Planning & Zoning Commission Hearing: November 17, 2022

Powerhouse 2 – #PDP210021

Summary of Request

1. Modification of 3.2.1(E)(5) Parking Lot Interior Landscaping

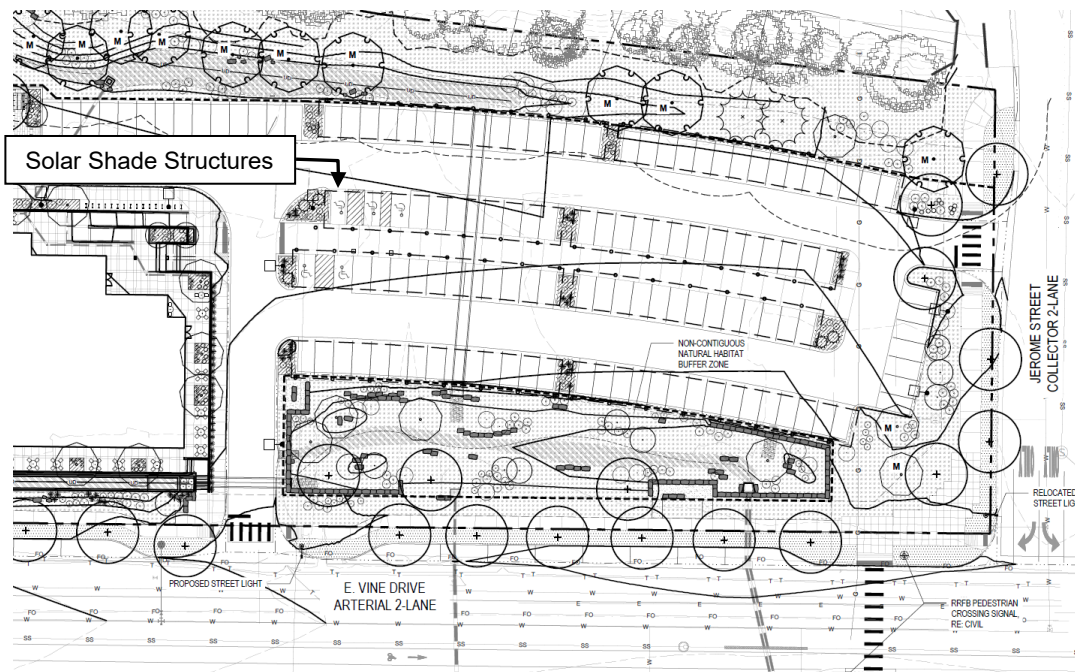
This standard requires canopy shade trees in islands in parking lots. The parking lot in the proposed plan has solar shade structures which preclude trees in the islands due to conflict with the structures and the functioning of the solar panels.

Staff finds that the modification would not be detrimental to the public good, and meets criteria (1), (2), and (4) -- "equal-to or better than", "defined community need", and "nominal and inconsequential from the perspective of the whole plan".

Not Detrimental to the Public Good. The architectural presence of the shade structures mitigates the appearance of the parking lot with visual interest and provides shade for the parking. The lot is placed behind extensive tree plantings between the parking and the street/sidewalk which provides the look and feel of a landscaped facility.

“Equal or Better”. The structures essentially act in lieu of trees to mitigate the parking lot appearance, and they provide more shading than the trees would provide, starting on day one of installation. Staff notes that they may generate interest and awareness of a sustainable approach to parking lots as part of the whole approach to the entire development plan. Staff noted that they also provide a degree of shelter from snow as a small side benefit although that is not a factor in findings.

“Nominal and Inconsequential”. The plan provides extensive tree plantings around the parking lot in generous landscape areas that exceed standards for perimeter landscaping, such that the property will be significantly defined by tree plantings in the foreground of public views of the lot. From the perspective of the entire landscape plan, the lack of trees within the lot will not be highly evident.

Figure 18.3 illustrates Street Frontage Build-To Range:

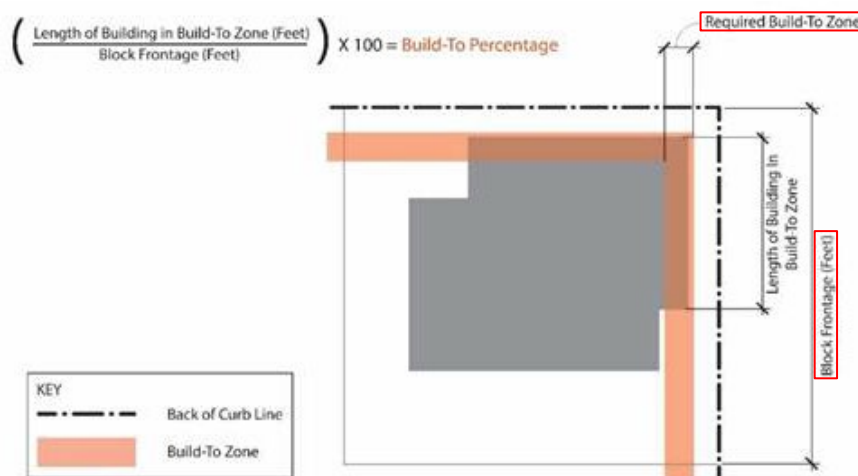
The intent of stating both a 24-foot Setback and a 34-44-foot Build-To requirement has not been understood.

Also, the metric for 50% of the Block Frontage has not been understood—typically that would refer to the length of a block face bounded by streets. It is likely intended to mean Lot Width. However in the Innovation Subdistrict, there are parcels such as this one, Woodward, New Belgium, Odells, and others where that interpretation would still not be feasible given parcel sizes and the nature of light industrial buildings.

In any case, staff understands that the general intent is for buildings to be placed to provide architectural presence along downtown streets, with front yard landscaping in the Green Edge areas. In this case, staff finds that the building placement with its architectural terrace features integrated into a landscaped streetscape, is completely consistent the intent, regardless of compliance with the specific metrics.

Staff offers the following findings despite the lack of understanding of what the standards mean.

“Physical Hardship”. The 50% Block Frontage Build-To Range requirement is not feasible because of the lengths of the block frontages along Vine and North College. Also, the placement of the building along Vine is determined by floodplain requirements to raise the building, creating the need for the plaza terrace system of steps, ramps, walls and railings which pushes the building back from the street to its proposed location.

If the architectural terrace features were considered part of the building, then it would be within 34-44 feet.

“As good or better”. The plan meets the apparent intent for Green Edge Street Frontage as well or better than would a plan with the building wall itself brought closer to the street.

Although the majority of the building along Vine is not within 34-44 feet of the street, the integral plaza terrace brings the architecture toward the street within that Build-To Range.

Staff will propose a code revision to clarify the intent and the metrics as part of the Land Use Code maintenance and update process.
